Docket No. 72-1040  
Certificate of Compliance (CoC) No. 1040

Subject: Responses to Second Request for Additional Information (RAI) for HI-STORM  
UMAX Canister Storage System (TAC No. L24664)

**ATTACHMENT 1 TO HOLTEC LETTER 5021014**  
**Responses to Second round RAIs**

Figure 2-2.1 Schematic of the Analysis Condition - HI-STORM UMAX Full Model (Oblique Flow)

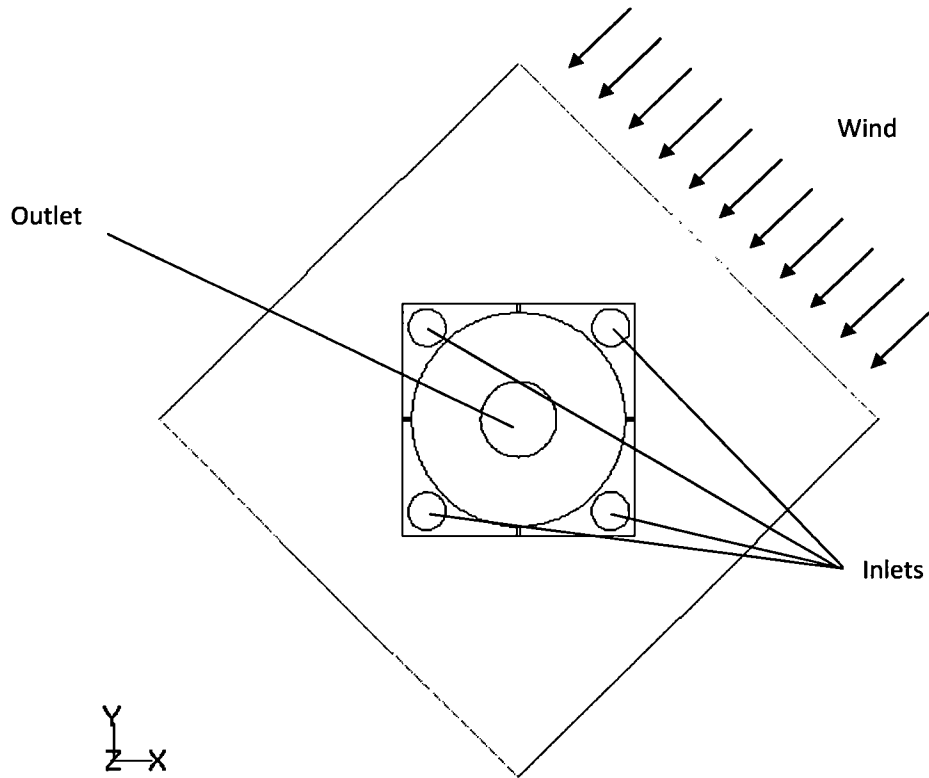
- 2-2 Justify by analysis that the direction of wind does not affect the aerodynamics and thermal performance of the HI-STORM UMAX system.

The safety analysis report (SAR) pages 1-15 states that the air passages in the closure lid are configured in such a manner that the aerodynamics in the system is not affected by the change in the horizontal direction of the wind. However, no analysis is provided to justify this statement. Additional analysis with varying wind direction should be provided.

We regret the imprecise statement on page 1-15 of the FSAR. The statement will be modified to recognize that the arrangement of inlet and outlet ducts in "UMAX" minimizes (but does not eliminate) the effect of wind direction on the peak cladding temperature (PCT). Absolute insensitivity to the wind direction is not feasible in any ventilated rectilinear cask array.

In order to evaluate effect of the directionality of the wind, as requested by this RAI and clarified in a public teleconference, an additional evaluation has been performed for the (previously identified) limiting wind speed of 7 mph that is constant and blowing in a fixed oblique direction as shown in Figure 2-2.1. Because of the loss of symmetry introduced by the oblique angle of the wind vector, the current half-symmetric model had to be expanded to a 360° model. This evaluation is performed for the MPC type that produced the highest PCT under normal (quiescent) condition of storage i.e. MPC-37 with short fuel loaded to heat load chart 1. The table below provides the PCT for both the 45 degree (oblique) flow and the previously calculated parallel air flow (Table 4.6.2 of Attachment 3 to Letter 5021010) cases:

<i>Item</i>	<i>PCT (deg C)</i>
Parallel Flow	378
Oblique Flow	381

As can be seen from the above results, the effect of oblique direction is quite minor and the predicted PCT corrected for the uncertainties discussed in Sub-section 4.4.2 of the FSAR remains below the 400 deg. C temperature limit.
